GENERAL INFORMATION

Request	-	Special Use Permit for a new gas station
Location	-	5765 Secor Road
Applicant / Developer	-	Skilken Gold Development, LLC 4270 Morse Rd Columbus, OH 43230
Owner	-	NG20, LP and Niki Olive Drive, LLC 11720 El Camino Real, Suite 250 San Diego, CA 92130
Tenant	-	Sheetz, Inc. 5700 Sixth Avenue Altoona, PA 16602
Engineer	-	Civil & Environmental Consultants, Inc. 8800 Lyra Drive Suite 300 Columbus, OH 43240

SPECIAL USE PERMIT
TOLEDO CITY PLAN COMMISSION
REF: SUP25-0024
DATE: August 14, 2025
TIME: 2:00 P.M.

SITE PLAN

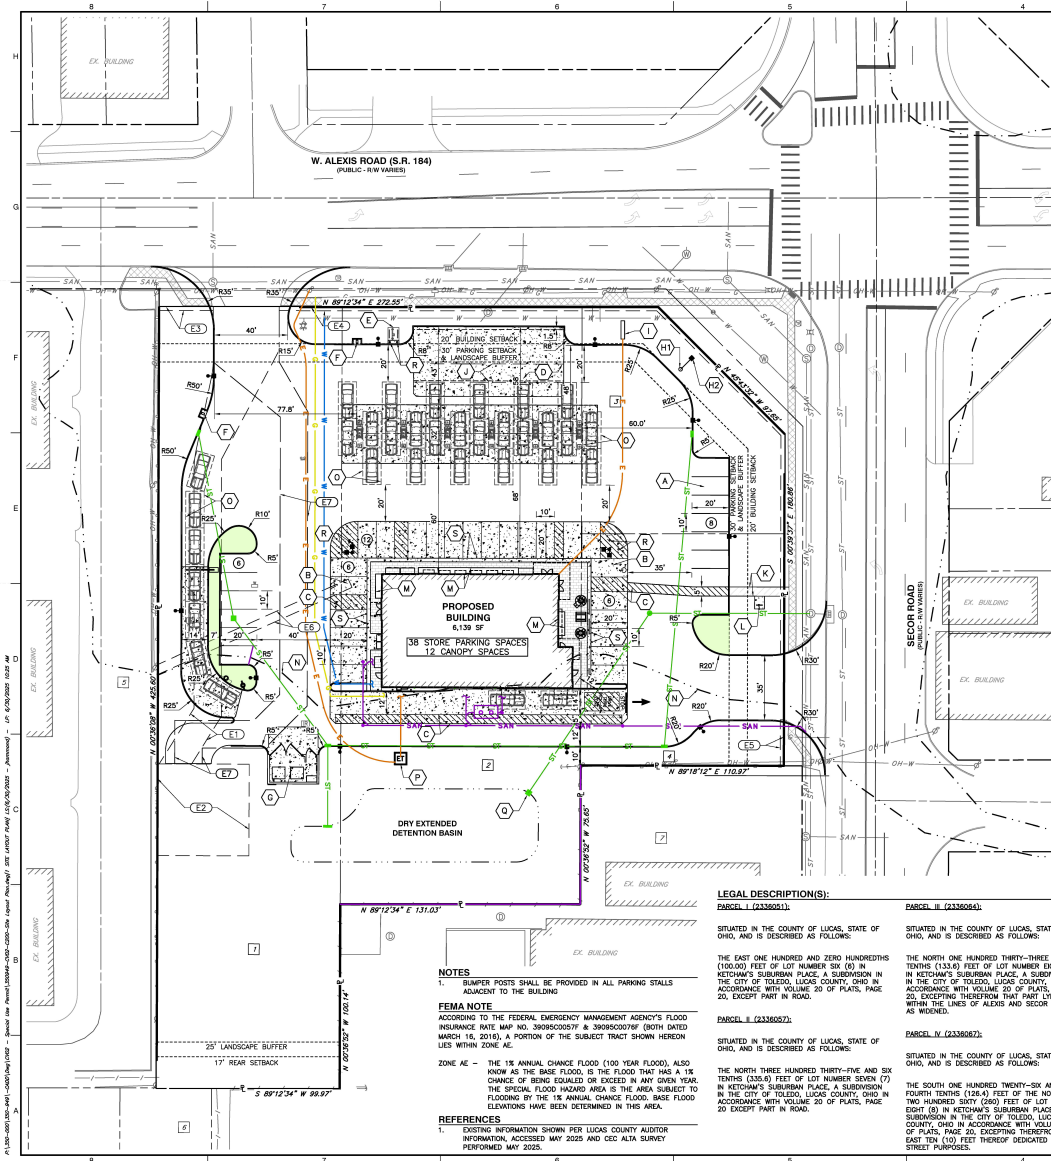
26. Free air shall be provided and maintained during operating hours of the station per TMC§1104.0903(D). Two (2) air stations are illustrated on the site plan. These air stations shall be free of charge.

30. Bicycle parking slots shall be provided per TMC§1107.0304 Schedule A for the proposed gas station and restaurant uses. Four (4) bicycle parking slots are required. The site plan depicts five (5) bicycle parking slots within the building setback and frontage greenbelt along Secor Road. **Not acceptable as depicted. The location of the proposed bicycle parking slots shall be relocated and a revised site plan submitted.**

32. Sidewalks shall be provided along all public streets in commercial districts per TMC§1107.1303. **Acceptable as depicted.**
33. Wheel stops shall be provided whenever a parking lot extends to a property line, sidewalk, planting strip, or building per TMC§1107.1907. Wheel stops are required for the thirty-eight (38) proposed marked parking spaces. **Not acceptable as depicted. Approved wheel stops shall be provided and depicted on a revised site plan for all parking spaces.**

34. Off-street parking facilities, including vehicular drives and maneuvering areas, in Commercial Districts are prohibited within fifteen (15) feet of street rights-of-way per TMC§1107.1907. **Not acceptable as depicted.** The site plan shall be revised so that no off-street parking facilities, including vehicular drives and maneuvering areas, are located within fifteen (15) feet of street rights-of-way

LANDSCAPE PLAN

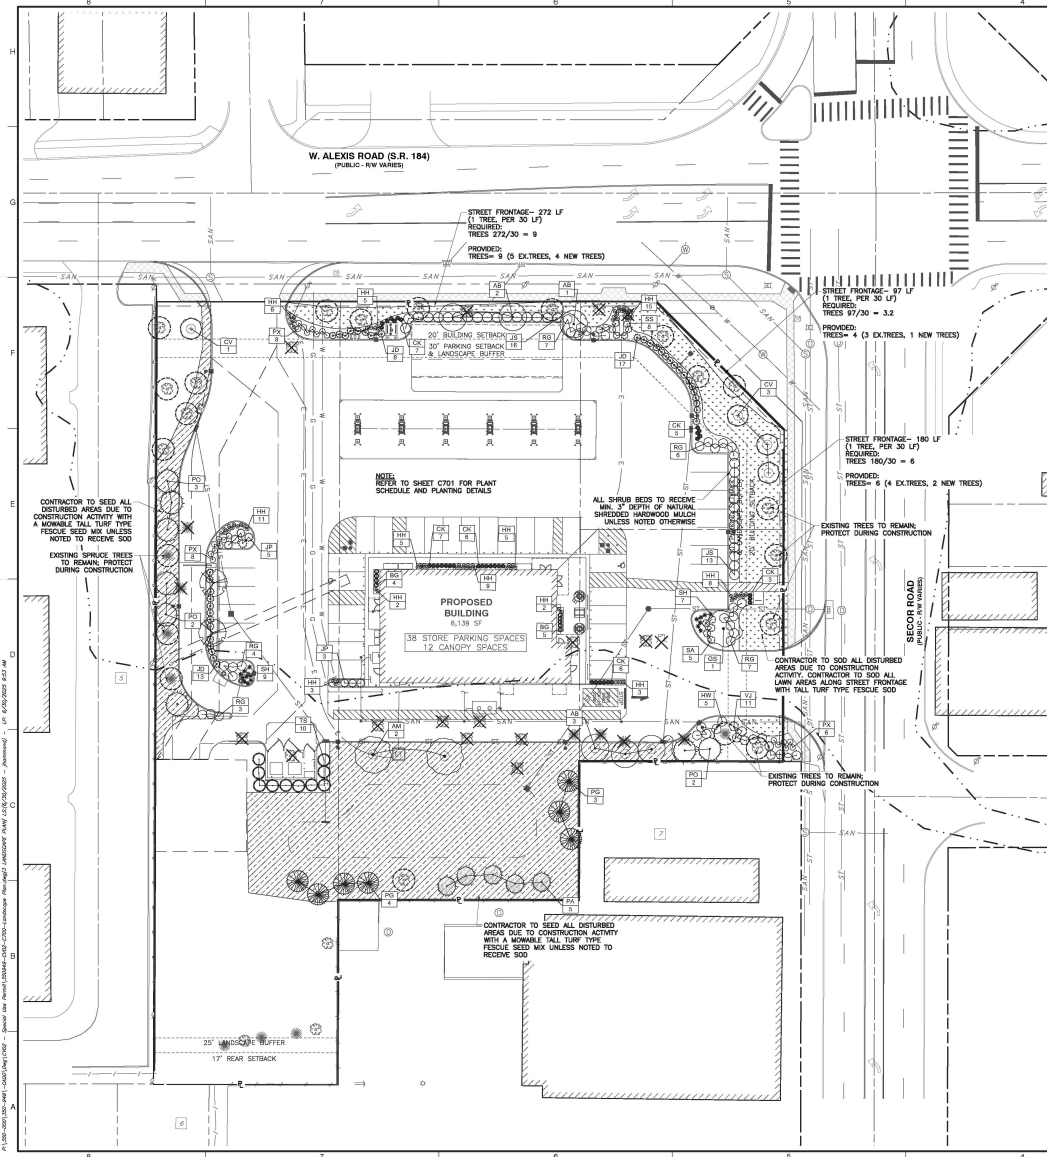
- a. A fifteen-foot (15') frontage greenbelt along Alexis and Secor Roads is required per TMC§1108.0202. **Not acceptable as depicted. Evergreen shrubs, species and sizes of existing trees to be preserved, and a fifteen-foot (15') wide frontage greenbelt shall be provided and depicted on a revised landscaping plan.**

- b. A Type "A" landscape buffer is required along a portion of the south property line where the abutting property is zoned RS6 per TMC§1108.0203. **Not acceptable as depicted. The required buffer shall be provided and depicted on a revised landscape plan.**

- f. Interior parking lot landscaping is required per TMC§1108.0204. Landscape terminal islands shall be provided at the end of each parking row. Two areas at either end of the parking spaces that face the front of the building are depicted with pavement markings and not landscape islands. **Not acceptable as depicted. Landscape islands shall be provided that are constructed with six (6) inch by eighteen (18) inch concrete curbing and illustrated on a revised landscape plan.**

- j. The location, number, height, diameter and species of any materials to be planted and maintained, as well as the location and number of any existing trees to be preserved. **Not acceptable as depicted. The species and size of trees to be preserved shall be provided.**

NORTH & EAST ELEVATIONS

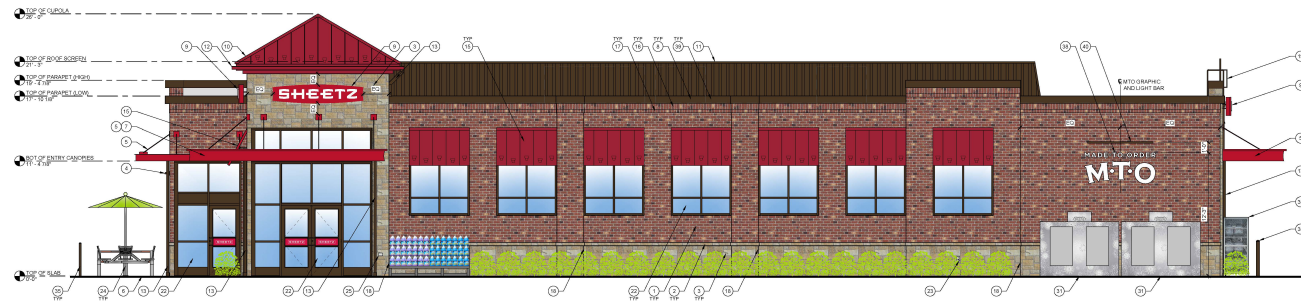
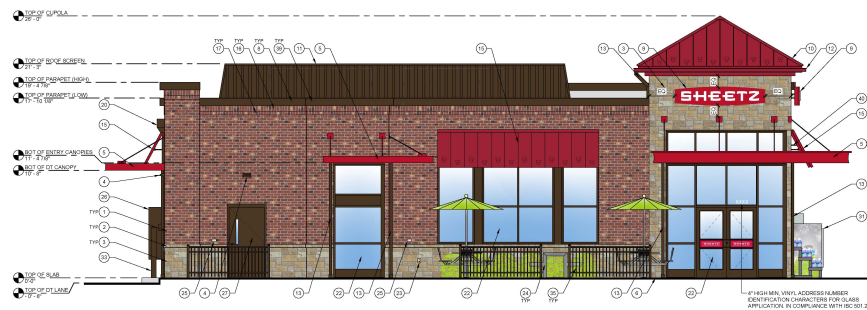
37. Transparent windows shall be provided on the north and east building elevations per TMC1109.0205(C.3). **Acceptable as depicted.**
38. All building elevations shall meet building material and color standards per TMC§1109.0500 since they are visible from a right-of-way. **Acceptable as depicted.**

39. All proposed signage shall meet the standards of TMC§1113 - Signs. **Wall signs are not acceptable as depicted. Wall signs are only permitted on building wall frontages facing Alexis and Secor Roads.**
